**RE: Foundation Modification for Lot # 130 Woodside Ridge – 2135 SW Killarney Ln
Lee's Summit, MO 64081 – Permit # PRRES20242325**

Everstead has determined that the subgrade material at proposed footing elevations does not have sufficient bearing capacity to properly support foundations for the structure specified in the approved permit plans. Everstead recommends that the following modifications be made to the foundation plan:

PIER LAYOUT

16" WIDE X 36" TALL TRENCH FOOTING:

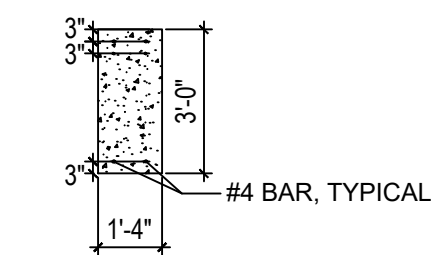
- (2) #4 BARS AT:
 - 3" FROM BOTTOM
 - 3" FROM TOP
 - 6" FROM TOP

8" WIDE X 4" TALL FOUNDATION WALL ON 16" WIDE X 8" TALL FOOTING:

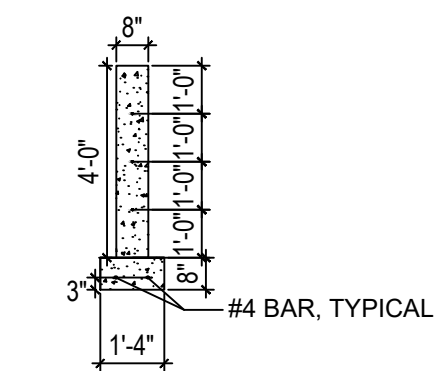
- (2) #4 BARS AT:
 - 3" FROM BOTTOM FOR FOOTING
- (1) #4 BAR AT:
 - 12" FROM TOP
 - 24" FROM TOP
 - 36" FROM TOP

8" WIDE X 9" TALL FOUNDATION WALL ON 16" WIDE X 8" TALL FOOTING:

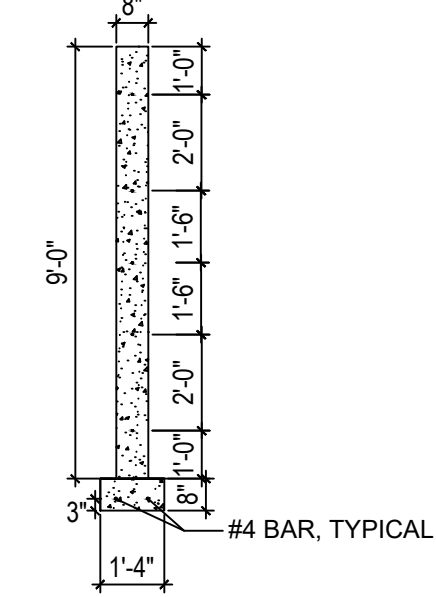
- (2) #4 BARS AT:
 - 3" FROM BOTTOM FOR FOOTING
- (1) #4 BAR AT:
 - 12" FROM TOP
 - 36" FROM TOP
 - 54" FROM TOP
 - 72" FROM TOP
 - 96" FROM TOP

STRUCTURAL SLAB SPECIFICATIONS:

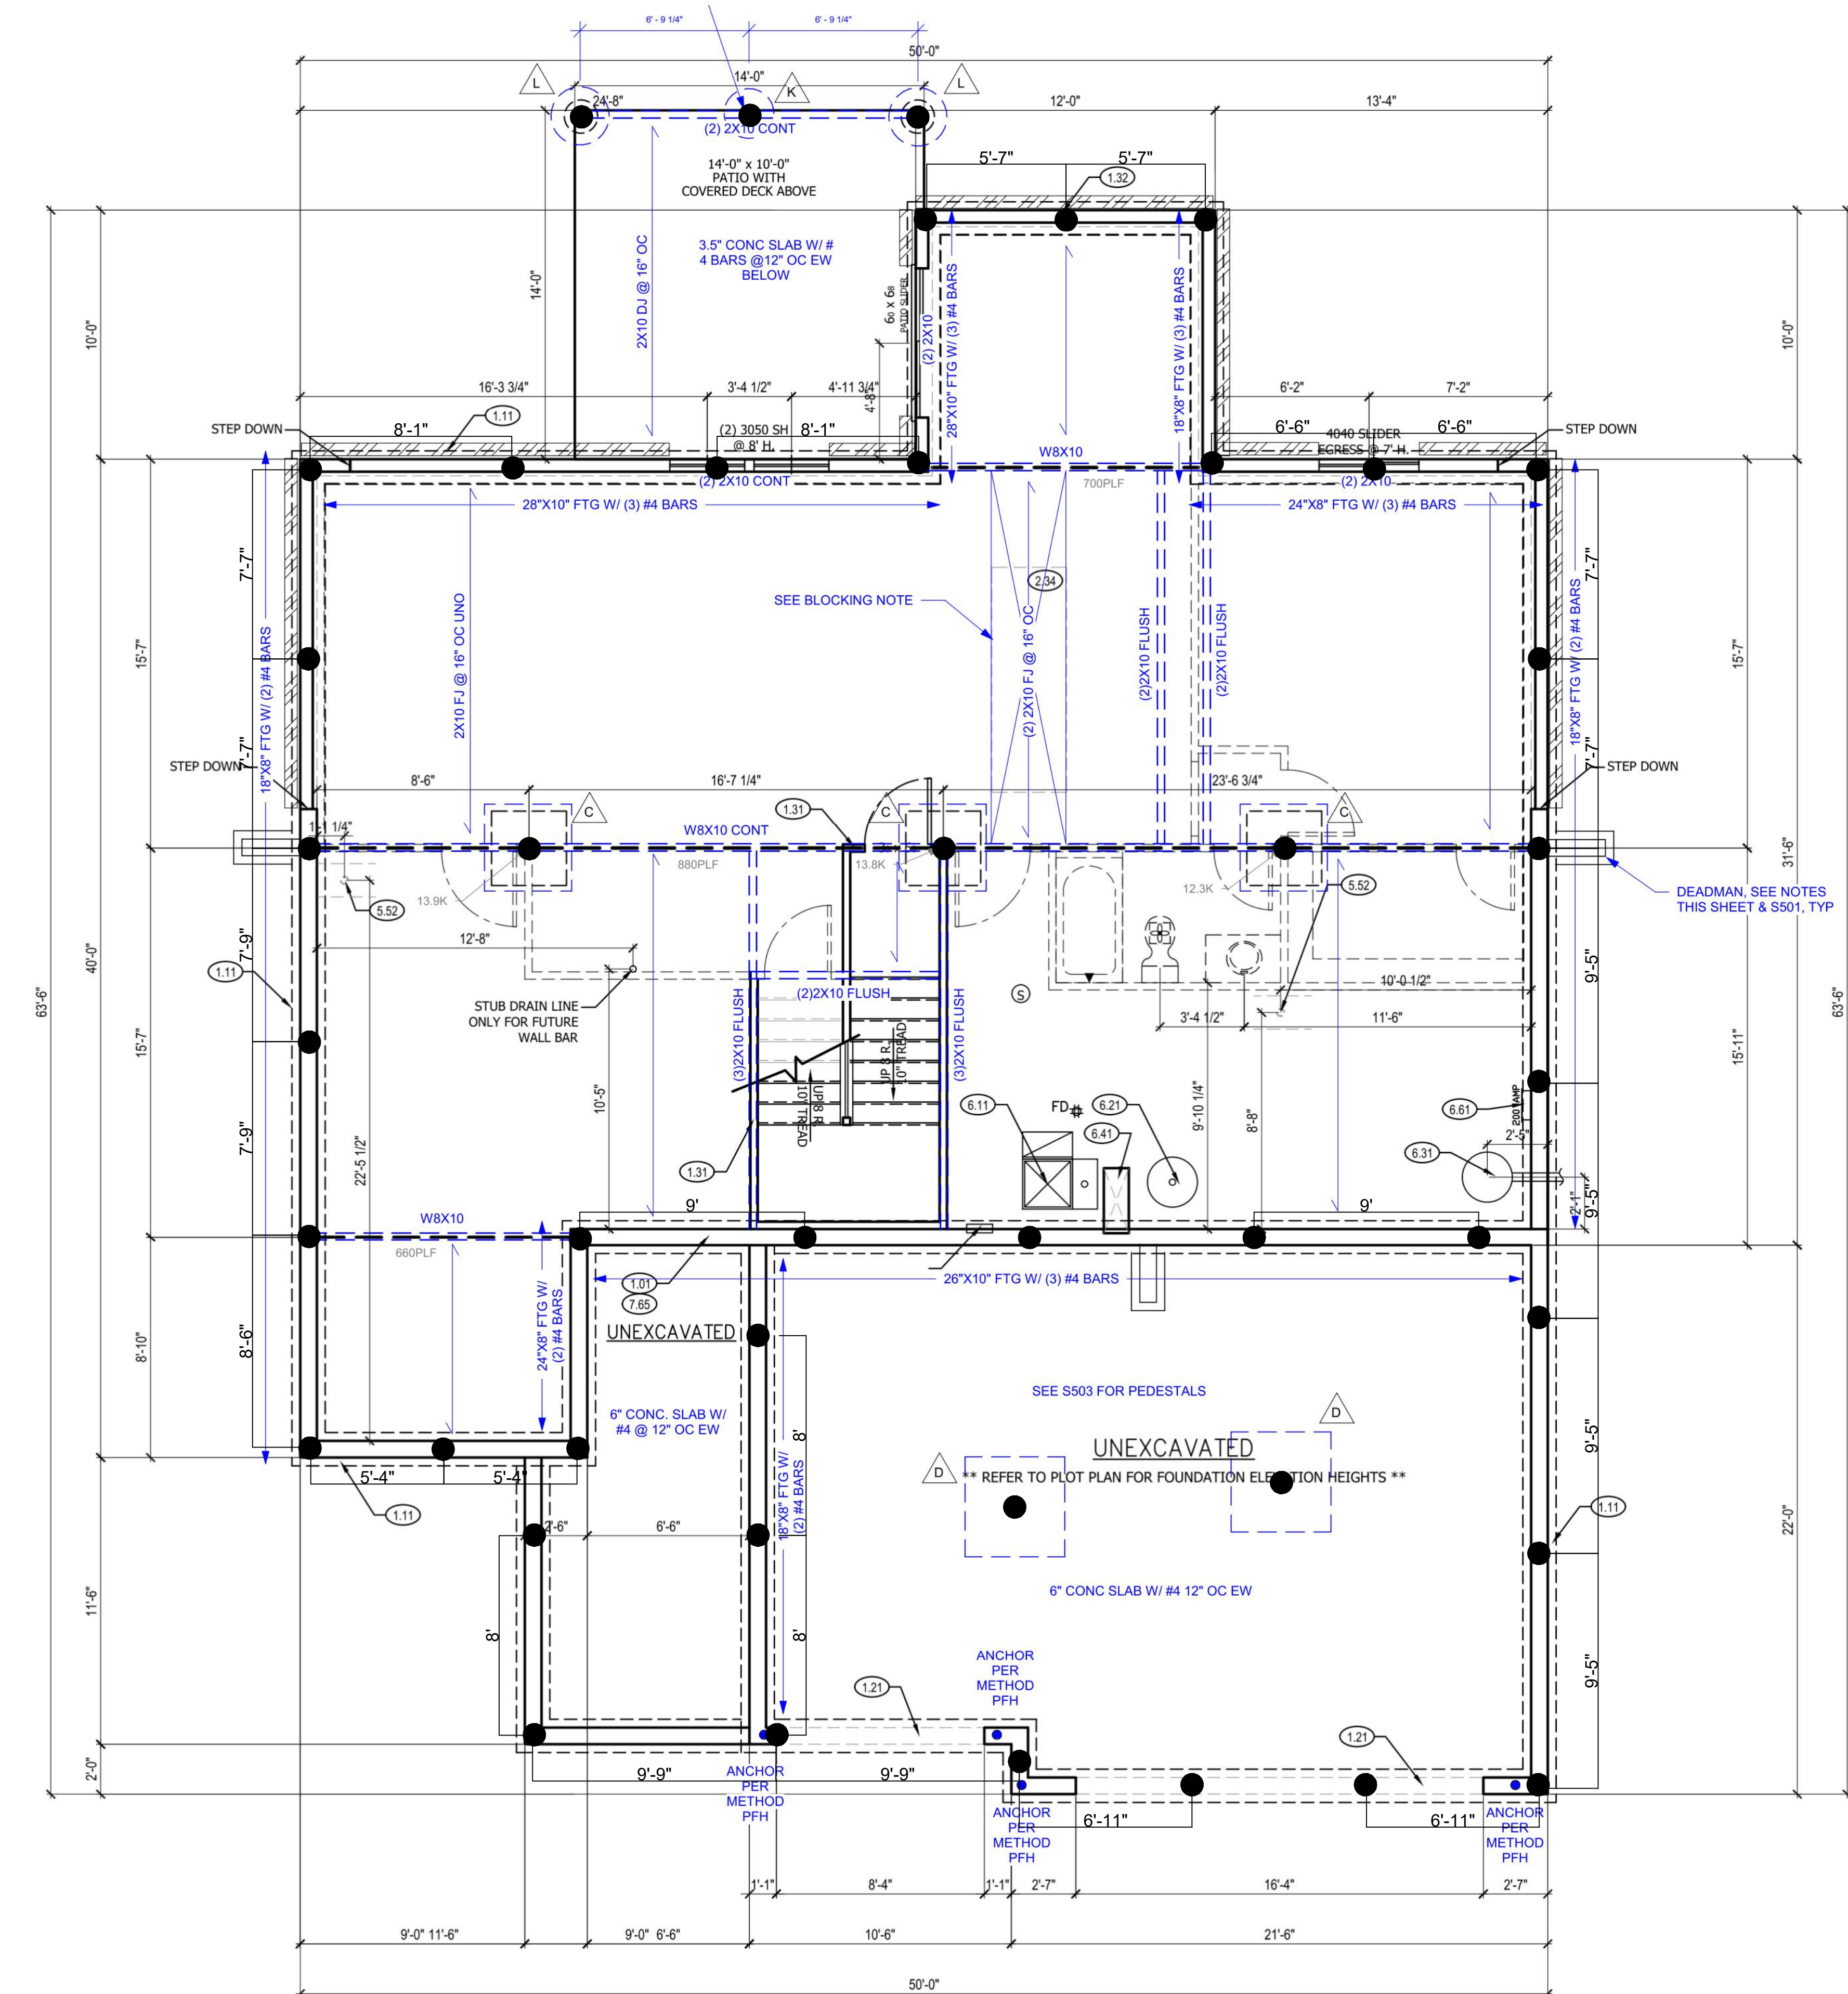
- PLACE 5" CONCRETE SLAB W/ #4 BARS AT 12" O.C. EACH WAY ON 1-1/2" CHAIRS.
- ADD (4) 10'-0" LONG #4 BARS EACH WAY OVER THE COLUMN PADS AND SLAB SUPPORT PIERS. PLACE WITH 1" TO 1-1/2" SLAB TOP COVER (3" CHAIRS).
- THE PERIMETER OF THE SLAB SHALL BEAR ON THE FOUNDATION WALLS AS FOLLOWS:
 - MINIMUM 3" KEYWAY OR FOOTING, OR
 - DRILL 5" DEEP AND PIN TO FOUNDATION WITH #4 BARS AT 12" O.C.

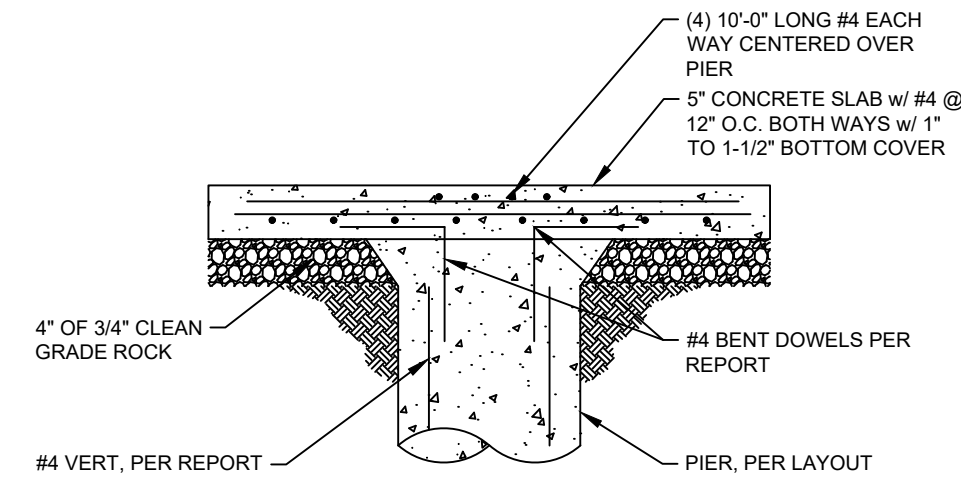
- Drill 18" diameter concrete piers per the attached layout.
- Piers shall be drilled to competent original limestone, sandstone, or shale.
- The piers shall be reinforced with (4) #4 bars for the depth of the pier.
- Lapping shall be no less than 24".
- (4) #4 bars shall extend a minimum of 24" into the footings.
- All piers shall be inspected by our firm prior to the placement of concrete.
